From: Osborn, Douglas [dosborn@sandia.gov]
Sent: Wednesday, September 26, 2012 10:38 AM
To: Bixler, Nathan E; Monninger, John; Ghosh, Tina; Fretz, Robert
Subject: RE: [EXTERNAL] Re: Newer Updated MACCS2 slides for 10/3 ACRS presentation

From: Ghosh, Tina
To: Fretz, Robert
Cc: Monninger, John; Szabo, Aaron; Stutzke, Martin; Basu, Sudhamay; Harris, Brian; Gibson, Kathy; Scott, Michael; Santiago, Patricia; 'Bixler, Nathan E' <nbixler@sandia.gov>; 'Osborn, Douglas' <dosborn@sandia.gov>
Sent: Tue Sep 25 22:43:55 2012
Subject: Newer Updated MACCS2 slides for 10/3 ACRS presentation

Figure B.1-4 Isopleths of equal pollutant concentration

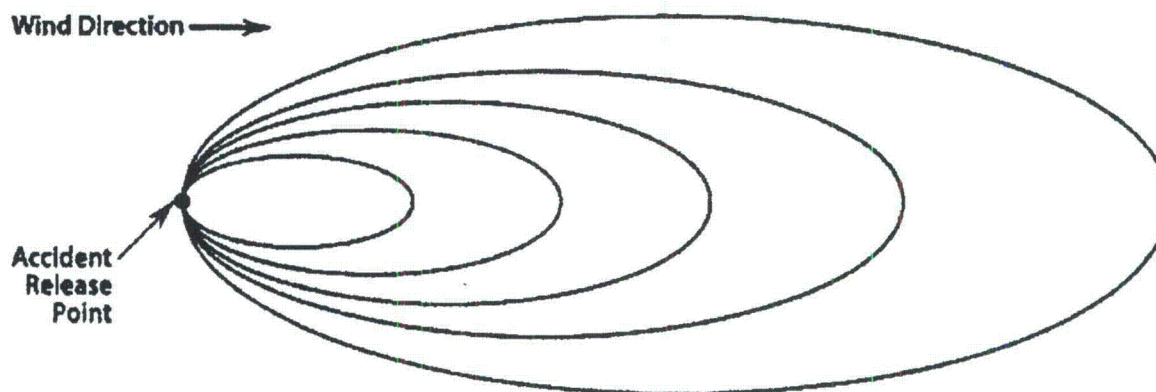
The distances reported for that row (e.g., 280 km² for Case 2) are not circular areas / radial distance from the plant.

Nate calibrated me on this as well. The area is something more like what you see in Fukushima. It's a contaminated area that looks more like a cigar shape downwind from the plant.

The reported results I provided from MACCS2 are a 'mean' contaminated land area, which means the area is not in a specific downwind direction. But considering MACCS2 uses a Gaussian plume model, any downwind contamination area will look like something shown in the figure below (taken from SOARCA Uncertainty Analysis – DRAFT).
